Camden County Planning Board Agenda for December 17th, 2019

STAFF REPORT MEETING OF:	RE:	Hampton Rd. Redevelopment
	Plan:	SP-12 -16-19
	Municipality:	Cherry Hill
	Applicant:	FMP CH Hampton. LLC
	Abuts County Route:	Cr. 636 Cuthbert Blvd & Cr. 623 Hampton Rd.

**CAMDEN COUNTY PLANNING BOARD
COUNTY ENGINEER'S REVIEW
OF SUBDIVISIONS AND
SITE DEVELOPMENT PLANS**

**COUNTY PLAN:
SP-12-16-19**

OVERALL SITE PLAN

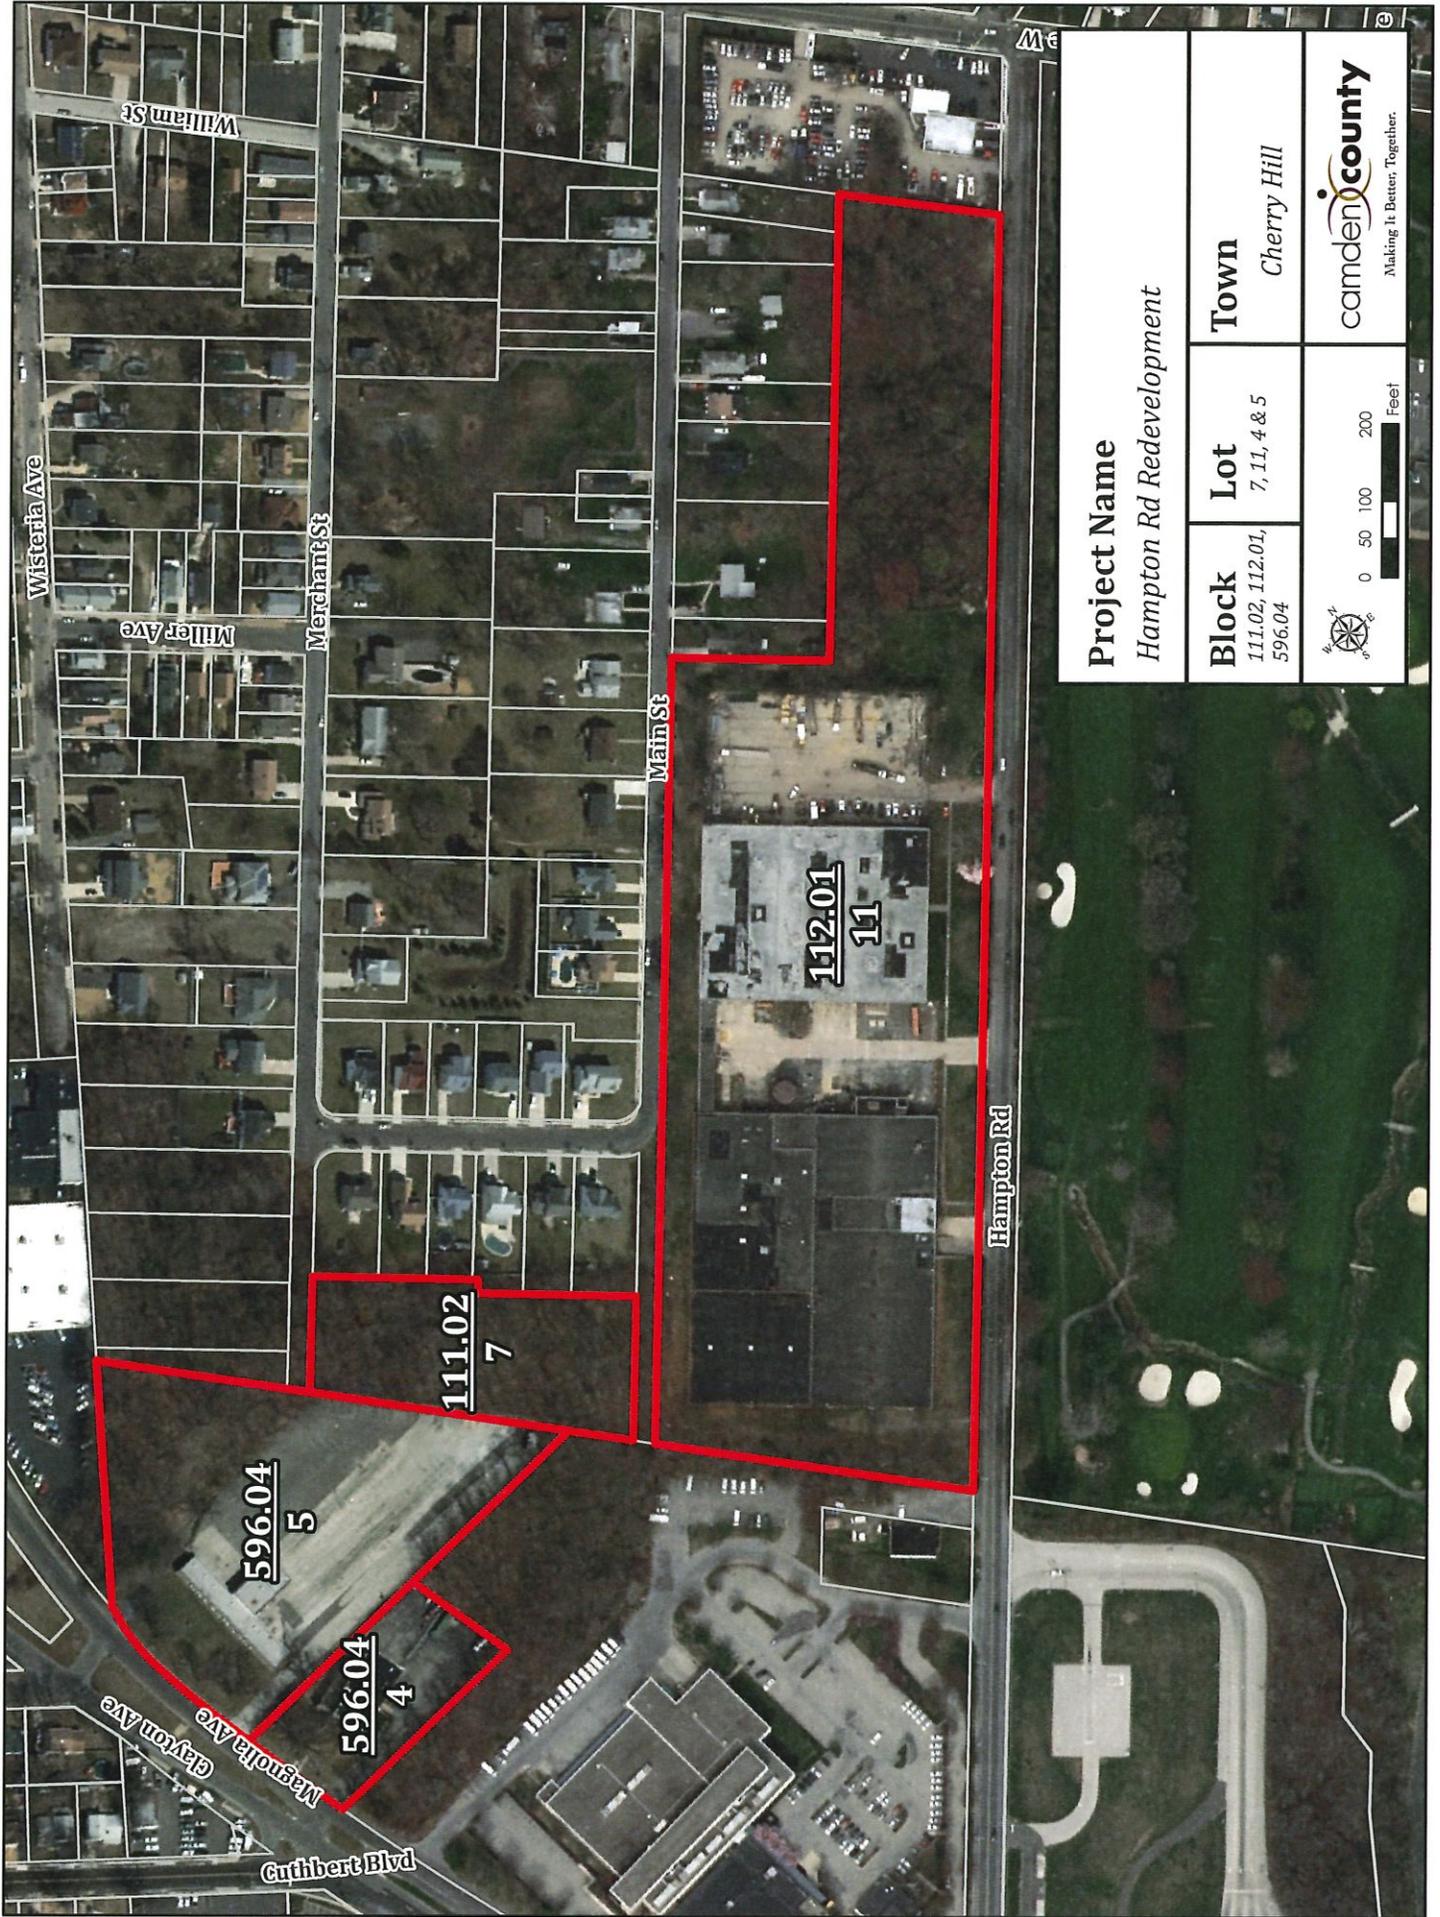
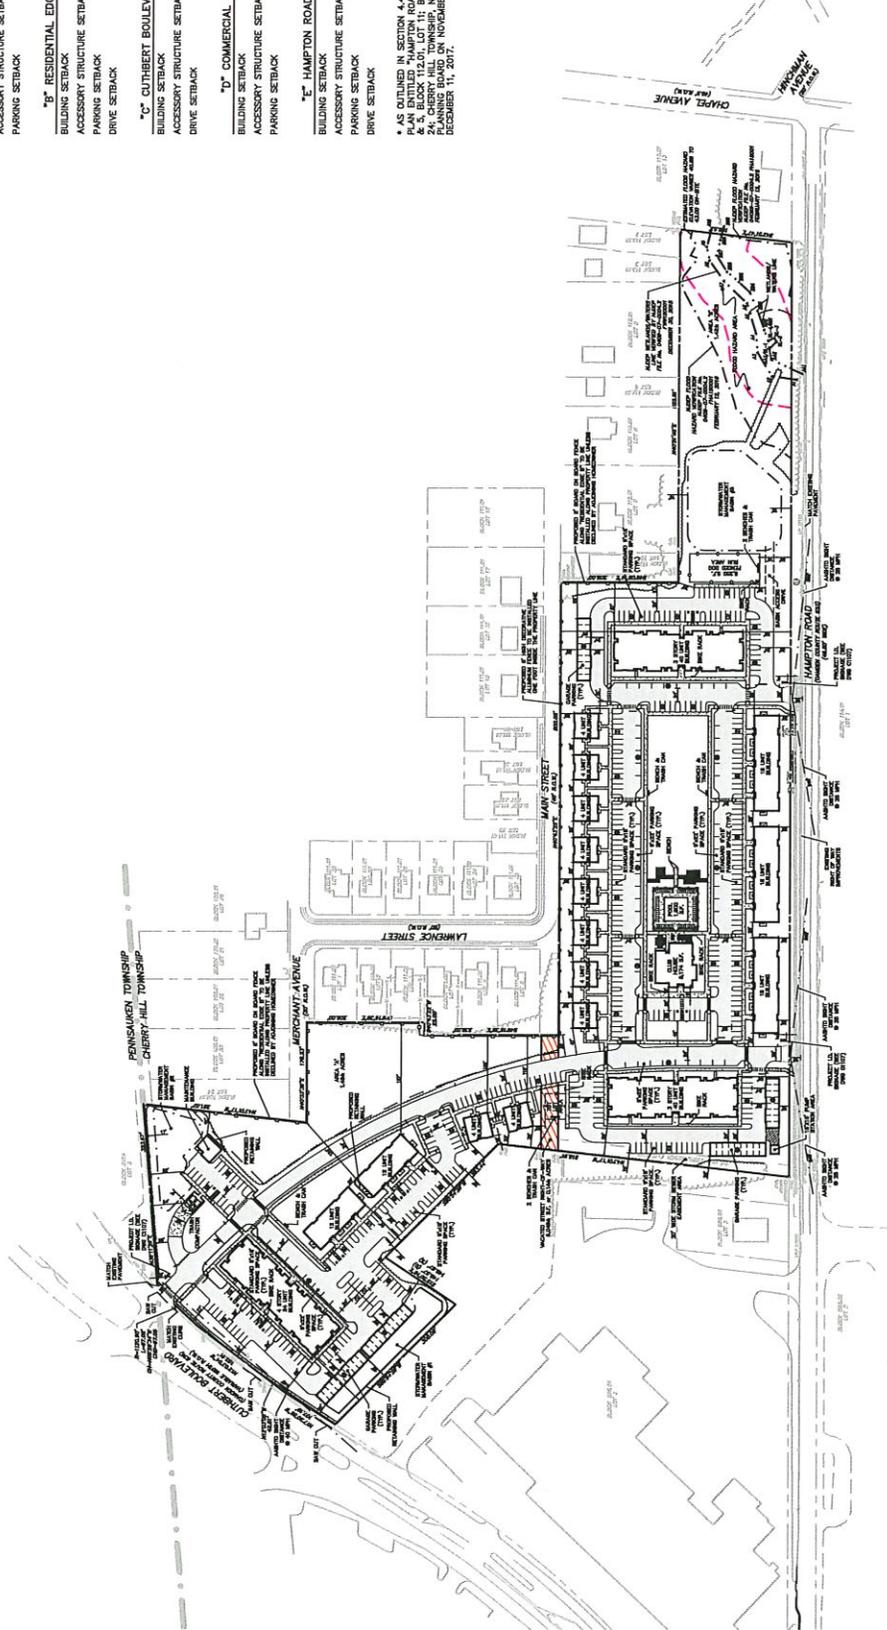
1. The Camden County Master Plan indicates that Magnolia Avenue (CR 637) has a proposed right-of-way of 60 feet, with an existing right-of-way of 50 feet. Although the plans and the current tax maps indicate the right-of-way width varies along the site frontage, this is because the site frontage is located where the 50-foot rights-of-way of Magnolia Avenue (CR 637) and Clayton Avenue (CR 638) converge and transition to the 100-foot Cuthbert Road right-of-way. Magnolia Avenue (CR 637) has an existing right-of-way of 50 feet north of the site, based on the current tax maps. Therefore, the applicant is required to provide 10 feet of additional right-of-way through a roadway easement to accommodate the future widening of Magnolia Avenue (CR 637) along the applicant's frontage. The following is noted:

- a. The site plan should be revised to indicate the roadway easement dedicated to Camden County.
 - b. The metes and bounds description of the roadway easement prepared by a licensed surveyor in the State of New Jersey should be submitted for prior review and approval.

1. The site plans indicate only the limited replacement of curb along Magnolia Avenue (CR 637), to eliminate depressed curbs and construct the proposed site access. However, the curb is in poor condition and should be replaced along the entire site frontage.

2. The plans indicate a County pavement restoration detail for asphalt pavement. However, based on the sawed and sealed joints observed in the surface course, the Magnolia Avenue (CR 637) pavement includes a concrete base course. The base course must be sawcut 2' from the curb line and restored, monolithic with the curb. However, since an additional surface course joint within the existing bike lane is not acceptable, the surface course must be resurfaced to the nearest joint along the lane line, and the joint should be sawed and sealed. The appropriate restoration and the standard County concrete pavement detail must be indicated on the plans.

4. The gutter slope along Magnolia Avenue (CR 637) appears to be less than 0.5%. A roadway profile along the centerline and proposed gutter line should be provided. Monolithic curb and gutter (see County Standard Detail 2) is required if gutter slopes are less than 0.5%.

5. The Demolition Plan appears to indicate the removal of a utility pole that laterally braces another utility pole within the Magnolia Avenue (CR 637) right-of-way. Utility coordination and an alternate means of bracing the utility pole appear to be required to accommodate removal of this pole. The plans should be revised to clarify this work.

7. Sight triangles are shown on the site plans for each site driveway. Although the sight triangles shown on the plan use appropriate lengths based on AASHTO recommendations, the values are applied incorrectly. The sight distances for left turn movements are shown to the left of the driveways, and vice versa. However, AASHTO recommends the sight triangle values for right turn movements be applied to traffic approaching from the left and vice versa. The plans should be revised accordingly. Additionally, the applicant shall be required to submit a deed (or deeds) describing easements for each sight triangle and dedicating each easement to the County of Camden.

The maximum grade of a driveway approach to a county road is 3% for a minimum distance of 25' from the edge of pavement of the intersecting county road. Based on site design constraints identified by the applicant's design professional and accepted by the County Engineer, the maximum grade of the driveway approach may be exceeded. However, in no instance shall a driveway approach grade to a road be more than 7%. Additionally, the maximum grade differential between the slope of the new driveway and the cross slope of the County roads shall not be more than 8%. The proposed grade of the site driveways appears to range from

approximately 5% to 7% within 25 feet of each County roadway. The largest anticipated delivery vehicles and emergency vehicles using the site should be identified. The site plans should be revised to limit each driveway grade or provide appropriate driveway profiles with a vertical curves or a series of grades that can accommodate the vehicles expected to use the driveway.

- 3.3.1.10.E Driveway and Apron Material
Depressed curb is not proposed along the proposed Magnolia Avenue (CR 637) site driveway. The site plans should be revised accordingly.

- 3.4.13 Sidewalks
Sidewalk is proposed along the Magnolia Avenue (CR 637) site frontage, approximately 10 feet from the curb line. The sidewalk should be constructed 5 feet from the face of curb, and within the existing right-of-way to facilitate future sidewalk extension within the adjoining right-of-way.

3. An overflow spillway for Basin 2 is shown in the report calculations and the plan detail but is not shown on the grading plan. The plans must be revised to indicate the emergency spillway, pipe

4. Based on the contours indicated on the grading plans, the Basin 2 embankment appears to be “V-shaped”, with a sharp crest. The lack of a broad crest may increase the risk of berm failure and inundation of the adjacent property. The Basin 2 berm design should be revised to provide a top width of 4-6 feet, and the plans should be revised accordingly.

1. No roadway or site access improvements are indicated along Hampton Road (CR 623). However, the plans indicate proposed utility connections along the northern site driveway, running through the aprons and pavement already constructed by the County. The plans should be revised to indicate these connections as existing if they have already been constructed, or show the appropriate restoration associated with these connections.

STAFF REPORT MEETING OF:	RE:	DR MEM, LLC
	Plan:	SP-15-8-19
	Municipality:	Gloucester Twp.
	Applicant:	DR MEM, LLC
	Abuts County Route:	Cr. 759 Little Gloucester Rd.

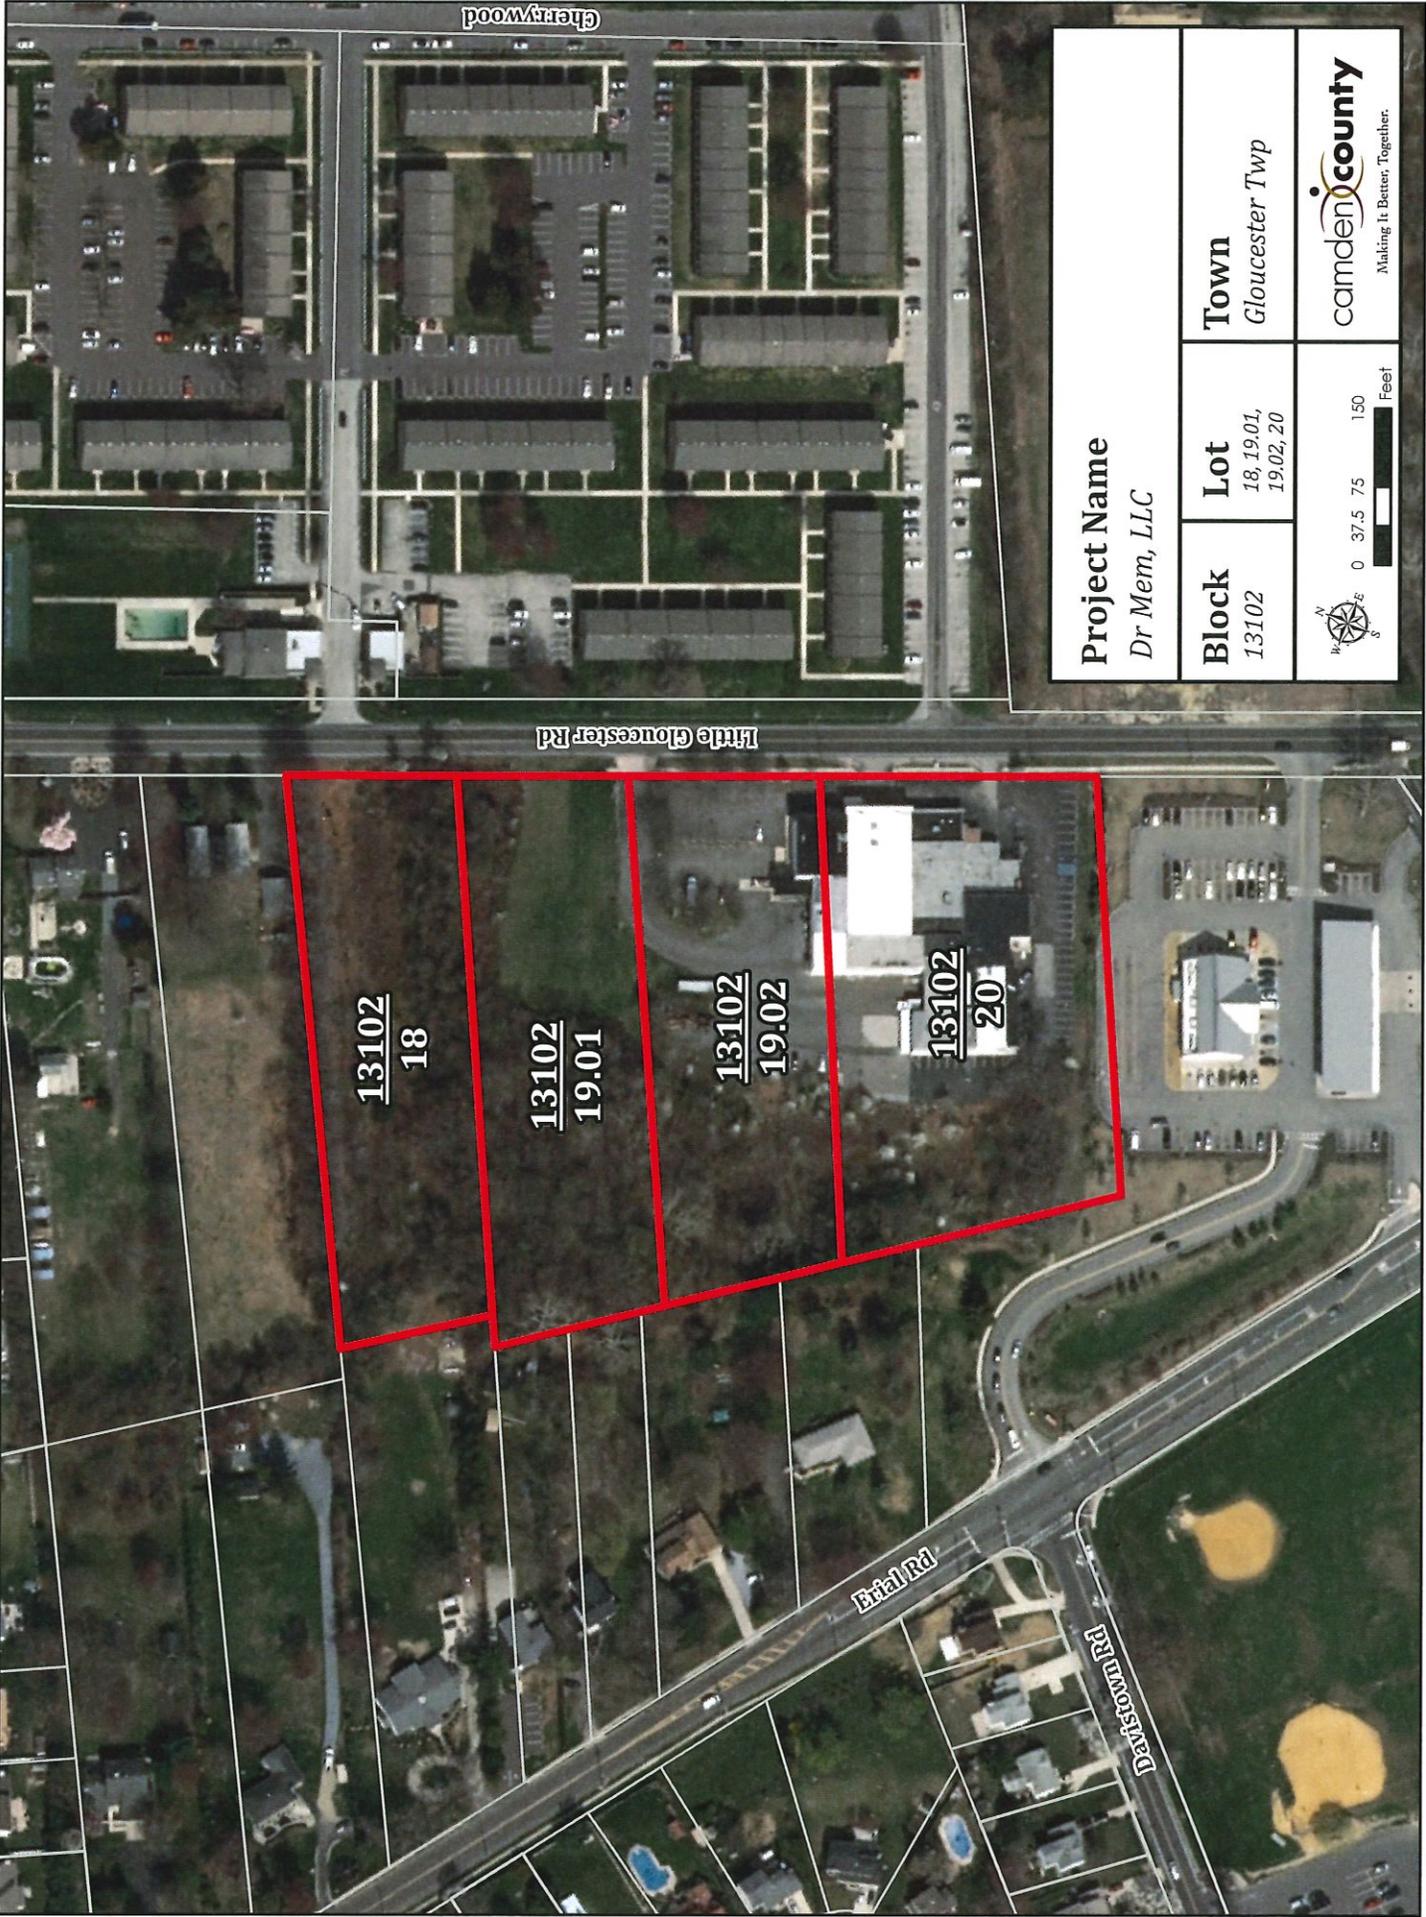
1. The Camden County Master Plan indicates that Little Gloucester Rd. (CR 759) has a proposed right-of-way of 74 feet, with an existing right-of-way of 49.5 feet. The applicant is required to provide additional right-of-way through a roadway easement to widen Little Gloucester Rd. from the centerline along the applicant's frontage for a width of 12.25ft. The following is noted:

- a. The site plan should be revised to indicate the roadway easement dedicated to Camden County.
 - b. The metes and bounds description of the roadway easement prepared by a licensed surveyor in the State of New Jersey should be submitted for prior review and approval.

- d. All plan sheets should be revised to indicate that the current width of the County Right of Way is 49.5 ft and not variable.

1. The Demolition Plan should clearly show all improvements to be removed within the County right-of-way.
2. The plans should include a note indicating "All sidewalk and curb within the County right-of-way along the property frontage that is deteriorated or presents a tripping hazard shall be replaced under the direction of the County Engineer or his/her representative."

5. It is recommended that the applicant close the center driveway and improve the southernmost driveway to a full access driveway. The northernmost driveway must be reconstructed to with curb radii and a driveway apron that conforms to County standards. Both driveways and site plan sheets must be updated to conform with the Development Regulations cited below.

3.3.1.10.G Stop Sign and Stop Bar (Plan must Conform) The site plan should include stop signs and stop bars at each driveway entering into the County Road.

7. The County recommends that the applicant provide a truck turning template that shows the centerline of Little Gloucester Rd. CR 759 and driveway turning radius that allows the largest truck entering and exiting the site to enter and exit the site without encroaching onto opposing lanes of traffic.
